Access Compliance Report

Public Rights-of-Way (Curb Ramps)

Intersection ID: 4118	Main Street: DAVID_COX_RD	Cross Street: OLD_SUGAR_CREEK_RD	Location: SE
ADA ID: 1E445094DC47	Ramp Type: Perp	Initial Pass/Fail: Fail	Overall Compliance: No
Severity Score: 12.5			
Codes/Mitigation Info/Possible Solution		Field Measurements/Component Compliance

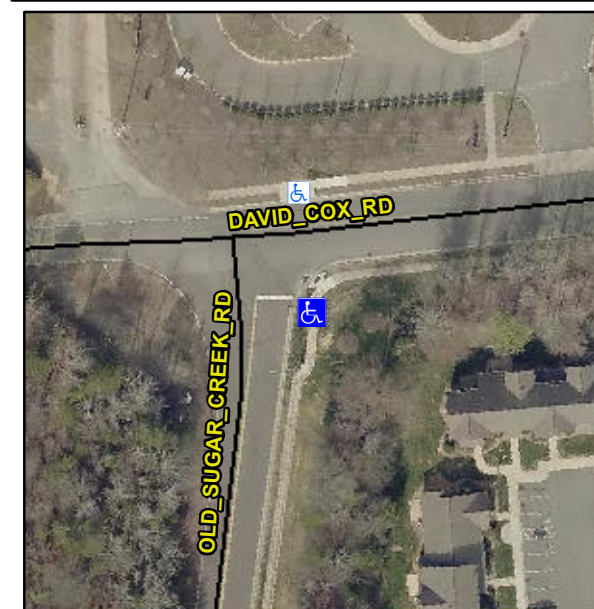
Remove & Replace Entire Ramp.

R304.2.2

Compliance	Description	Data	Compliance	Description	Data
N/A	Ramp Length (in)	48.0	No	Ramp Slope (%)	10.0
Yes	Ramp Width (in)	48.0	Yes	Ramp XSlope (%)	0.1
N/A	Flare Type LT	N/A	N/A	Flare Type RT	N/A
N/A	Flare Slope LT (%)	N/A	N/A	Flare Slope RT (%)	N/A
N/A	Flare Traversable LT?	N/A	N/A	Flare Traversable RT?	N/A
N/A	Landing Length (in)	N/A	N/A	DWS Provided?	N/A
N/A	Landing Width (in)	N/A	N/A	DWS Contrast?	N/A
N/A	Landing Slope (%)	N/A	N/A	DWS Length (in)	N/A
N/A	Landing X Slope (%)	N/A	N/A	DWS Full Width?	N/A
N/A	Landing Curb? (Y/N)	N/A	N/A	DWS Offset (in)	N/A
N/A	Shared Landing?	N/A			
N/A	Gutter Ponding?	N/A	N/A	Gutter Slope (%)	N/A
N/A	Gutter Lip Ht (in)	N/A	N/A	Gutter X Slope (%)	N/A
N/A	Painted X Walk1?	No	N/A	Painted X Walk2?	N/A
	X Walk 1 Direction	To N		X Walk 2 Direction	N/A
N/A	X Walk 1 Width (in)	N/A	N/A	X Walk 2 Width (in)	N/A
	X Walk 1 Slope (%)	4.3		X Walk 2 Slope (%)	N/A
	X Walk 1 X Slope (%)	1.8		X Walk 2 X Slope (%)	N/A
